Remarks

Applicant's invention is directed to a multipackage module having an inverted second package stacked over a first package, in which the z-interconnection between the stacked packages is by wire bonds, and in which at least one of the packages is provided with an electrical shield. The multipackage module according to Applicant's invention is made by providing a first package having an electrical shield, stacking a second package in an inverted orientation onto an upper surface of the shield, and electrically interconnecting the packages by wire bonds. According to the invention, the packages may be individually tested, and only packages determined to be "good" are used to assemble the stacks, providing improved yield in the resulting multipackage modules.

CPAC 1029-4

Fig. 6B

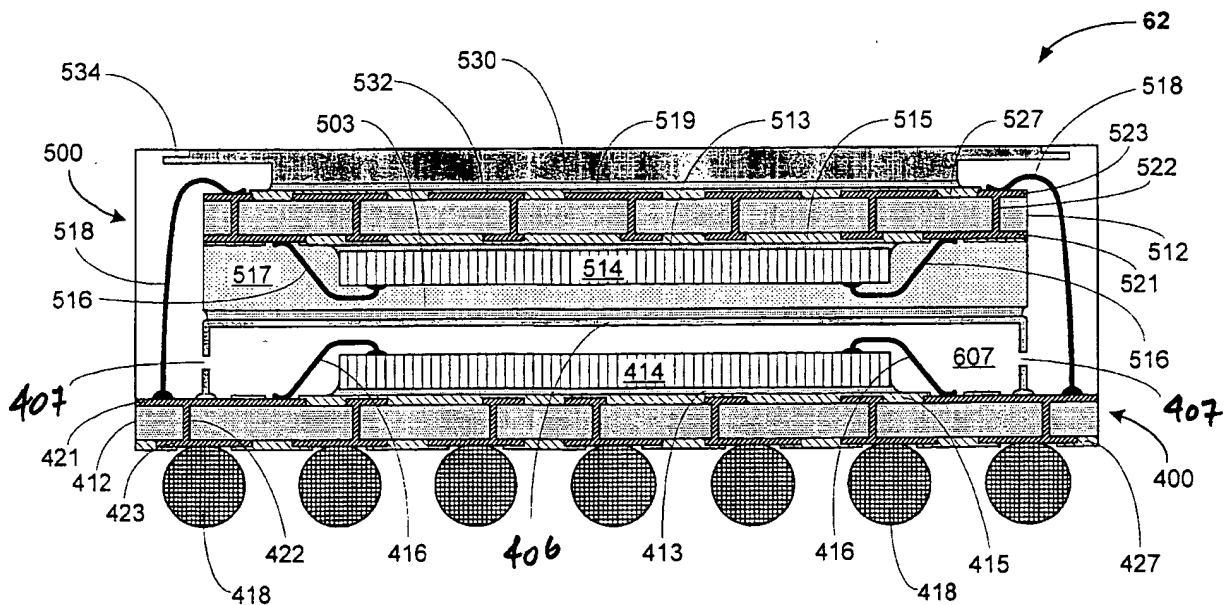
FIG. 6B is amended herein by insertion of missing reference numeral 406, and 407 (2 instances), to be consistent with the description and with the reference numeration of FIG. 6A.

Fig. 7A

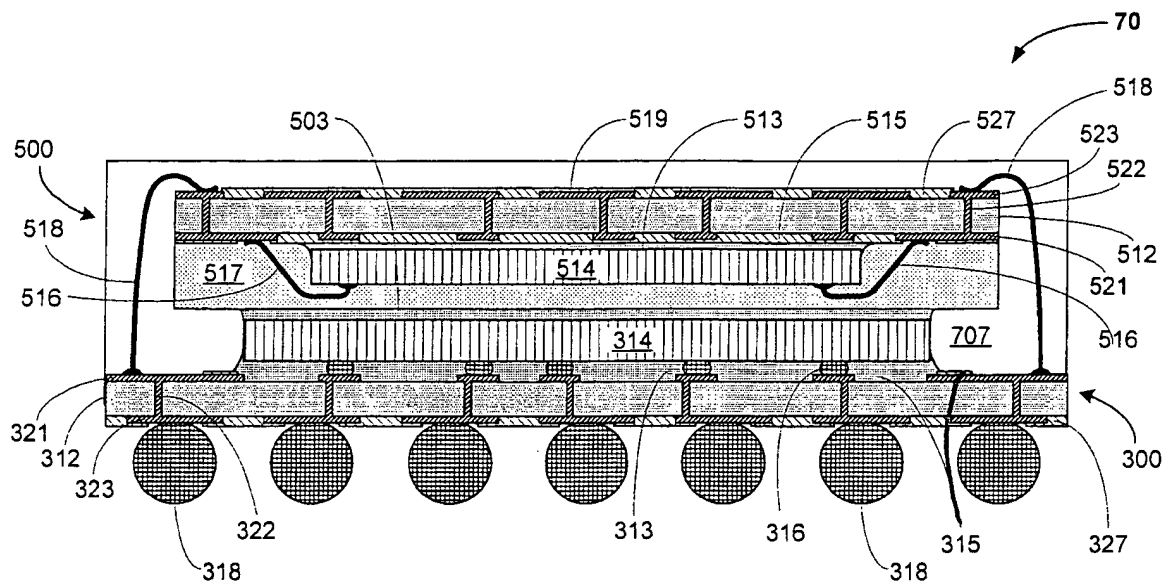
The Examiner objected to the drawings as failing to comply with 37 CFR 1.84(p)(4), asserting that "reference characters '313' and '315' have both been used to designate the adhesive" and noting that it was unclear where the lead line from reference numeral "315" pointed. Accordingly, in FIGs. 7A, 7B and 7C, the lead line from reference numeral **315** is moved, to indicate the "solder mask", see paragraph [00140]. It is noted that reference numeral **313** indicates the underfill, see paragraph [00136].

Fig. 8B

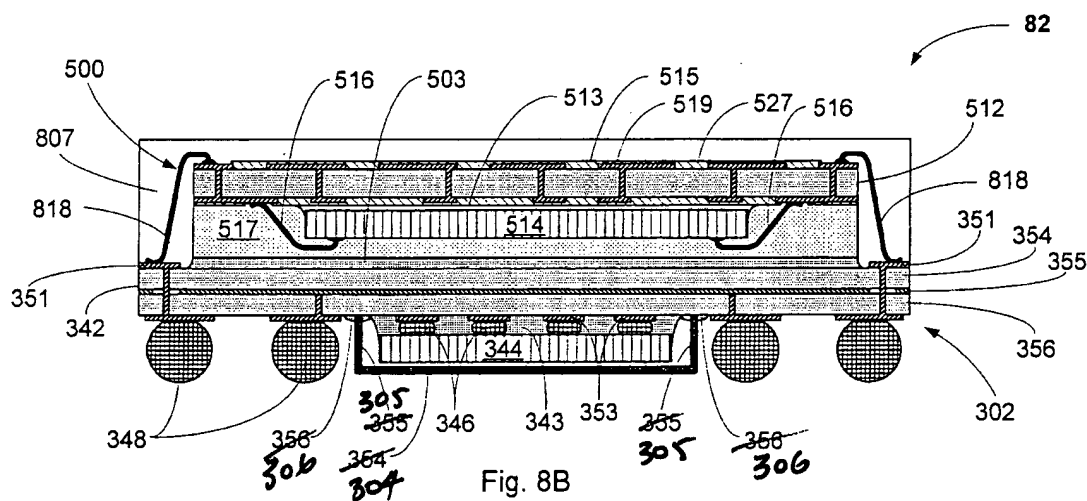
The attached sheets of drawings include changes to FIGs. 6B, 7A, 7B, 7C and 8B. Sheet 5 / 20, which includes FIGs. 6A and 6B, replaces original sheet 5 / 20 including FIGs. 6A and 6B; sheet 6 / 20, which includes FIGs. 7A and 7B, replaces original sheet 6 / 20, including FIGs. 7A and 7B; sheet 7 / 20, which includes FIG. 7C, replaces original sheet 7 / 20, including FIG. 7C; sheet 8 / 20, which includes FIGs. 8A, 8B and 8C, replaces original sheet 8 / 20, which includes FIGs. 8A, 8B and 8C. In FIG. 6B previously omitted reference numerals **406** and **407** (2 instances) are added. In FIG. 7A, 7B and 7C, the lead line running from reference numeral **315** is repositioned. In FIG. 8B reference numerals **304**, **305** (2 instances) and **306** (two instances) replace erroneous instances of reference numerals **354**, **355** and **356**, respectively.

Fig. 8C

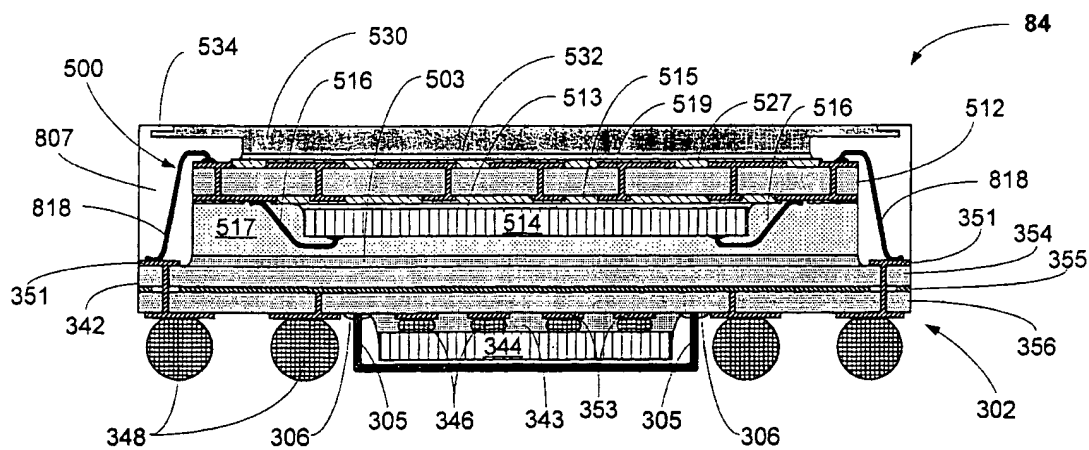
"355" is replaced with -- 305 --, "356" is replaced with -- 306 --, and "354" is replaced with -- 304 -- (paragraph [00165]) to make the text consistent with the reference numeration of FIG. 8C and to avoid use of any reference numeral to identify more than one feature. It is noted that metal layer 355 is sandwiched between dielectric layers 354, 356 in bottom package substrate 342 (*see, e.g.*, paragraph [00157], FIGs. 8A, 8B, 8C). Accordingly, FIG. 8B is amended to make the reference numeration consistent with that of FIG. 8C, by replacing the instances of reference numerals 354, 355, 356 that are directed to the lower planar part and the legs or sidewalls of the heat spreader, and the adhesive by which the heat spreader is affixed to the substrate, with, respectively, numerals 304, 305, 306;
